**DEPARTMENT OF TRANSPORTATION
STATE OF GEORGIA**

FILE P. I. No. 110690-, Franklin County **OFFICE** Preconstruction
NH-IM-85-2(173)
I-85 Widening from North of SR 51 **DATE** April 9, 2008
To North of SR 320

SUBJECT APPROVED REVISED PROJECT CONCEPT REPORT

REVISED PROJECT CONCEPT REPORT

STATE OF GEORGIA
 DEPARTMENT OF TRANSPORTATION
 OFFICE OF CONSULTANT DESIGN
TYPICAL SECTIONS

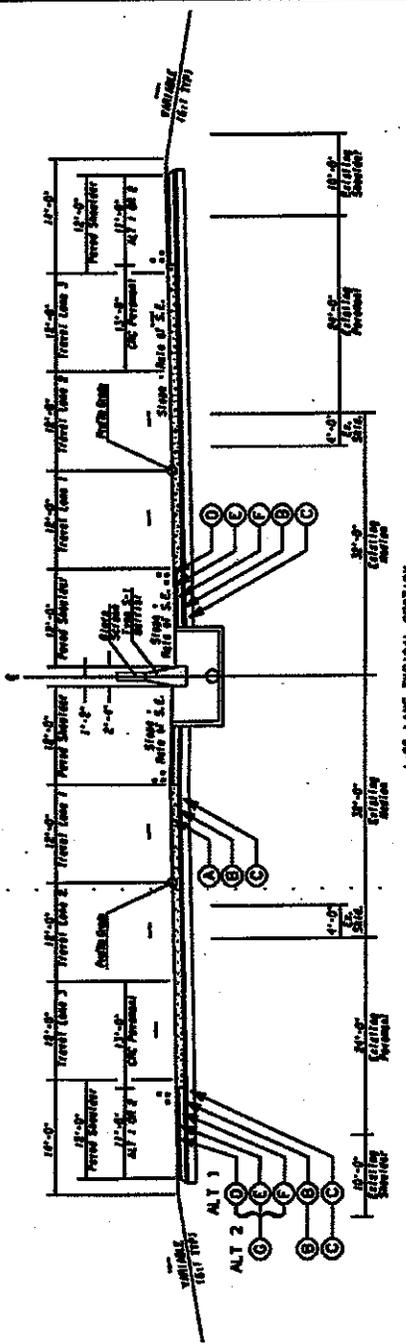
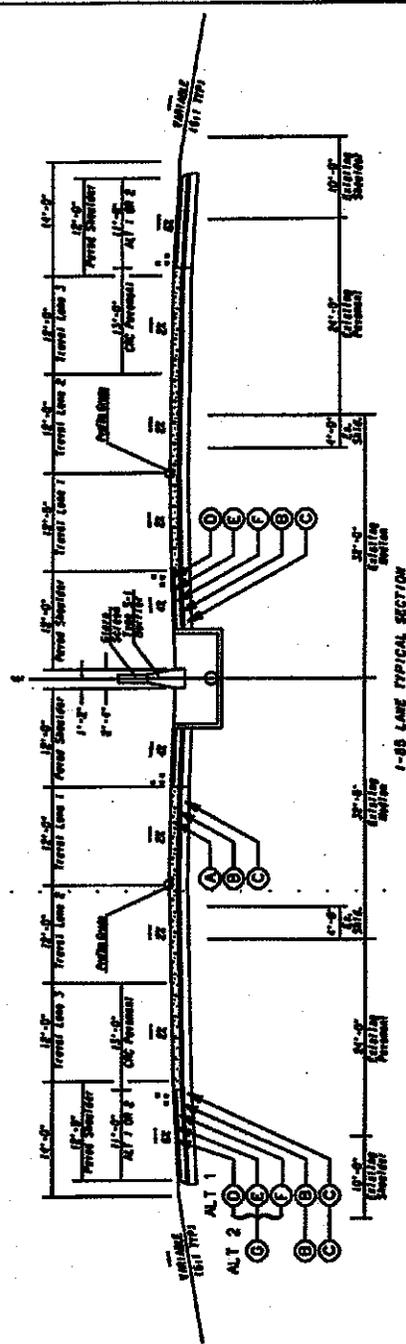
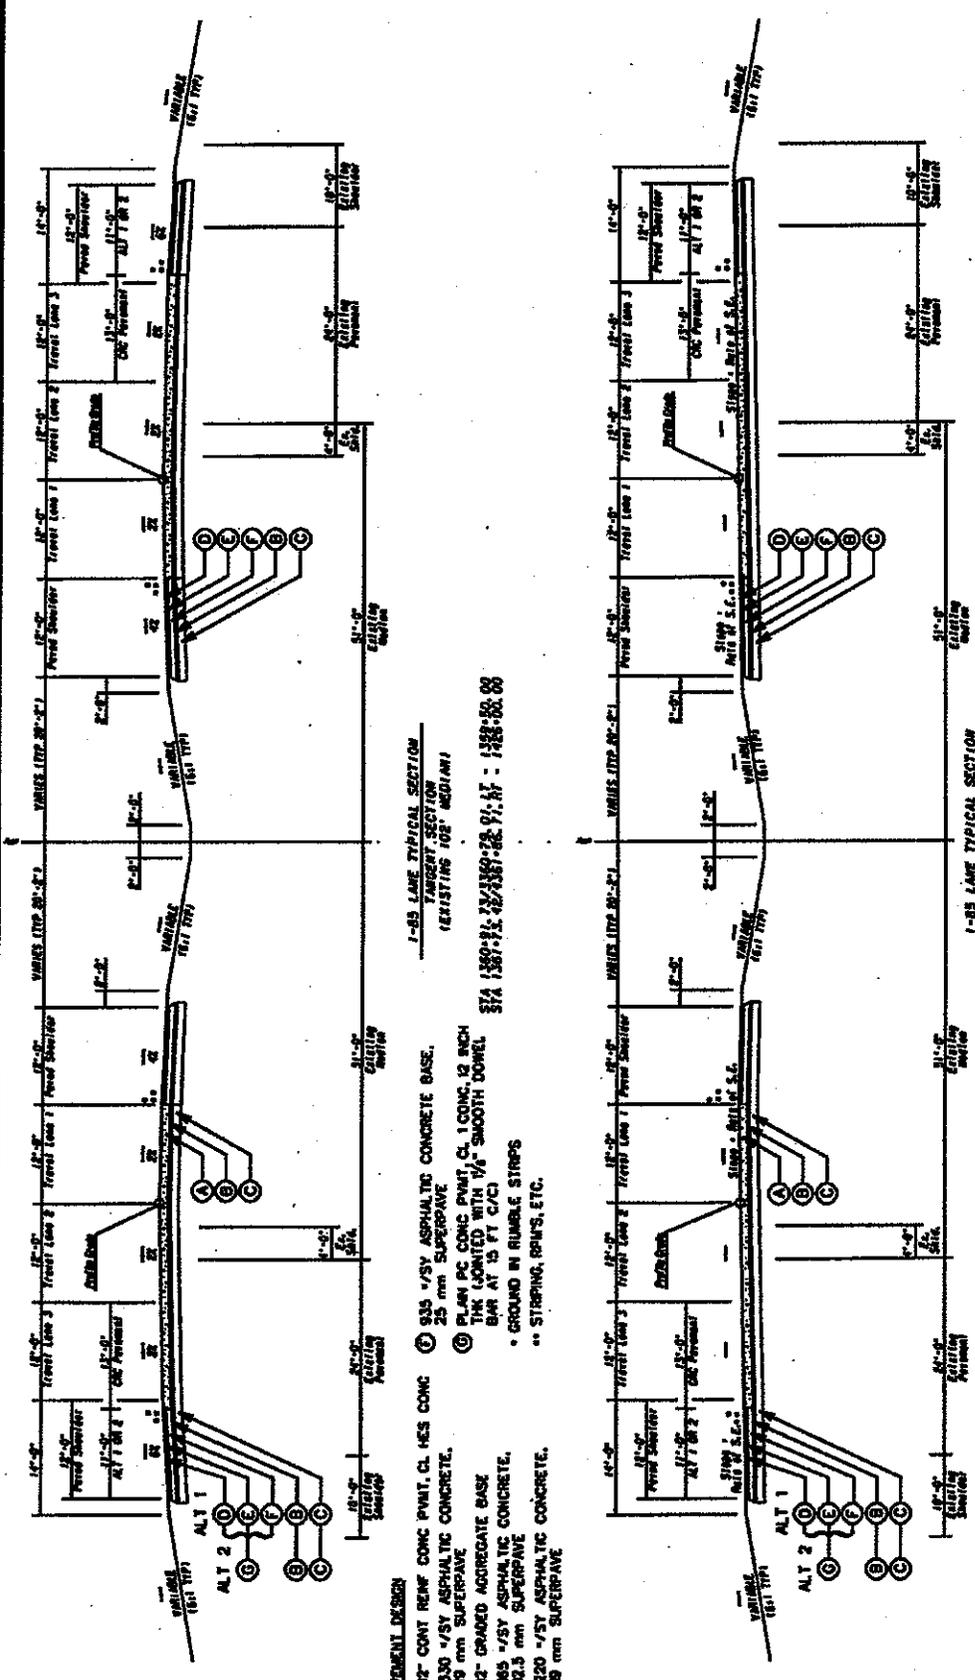
- **The revised typical section:**
 - Mile log 160.0 – 160.3 & 161.1 – 164.4
 - Six 12' lanes, outside lane paving will extend 1'-0" into the paved outside shoulder but will be striped at 12'-0"
 - Median Barrier (Type S-1, S-2 or S-3)
 - 13'-2" inside shoulder (12' paved)
 - 14' outside shoulder (12' paved), includes 1'-0" extension of outside lane pavement
 - Concrete pavement section with full depth reconstruction of existing pavement and an alternative pavement section (asphalt or concrete) for the paved shoulders
 - Mile log 160.3 – 161.6
 - Six 12' lanes, outside lane paving will extend 1'-0" into the paved outside shoulder but will be striped at 12'-0"
 - 64'-4" depressed median
 - 14' inside shoulder (12' paved)
 - 14' outside shoulder (12' paved), includes 1'-0" extension of outside lane pavement

- o Concrete pavement section with full depth reconstruction of existing pavement and an alternative pavement section (asphalt or concrete) for the paved shoulders

The revised typical section will begin on I-85 just north of SR 51 and extend throughout the project corridor, ending just north of SR 320.
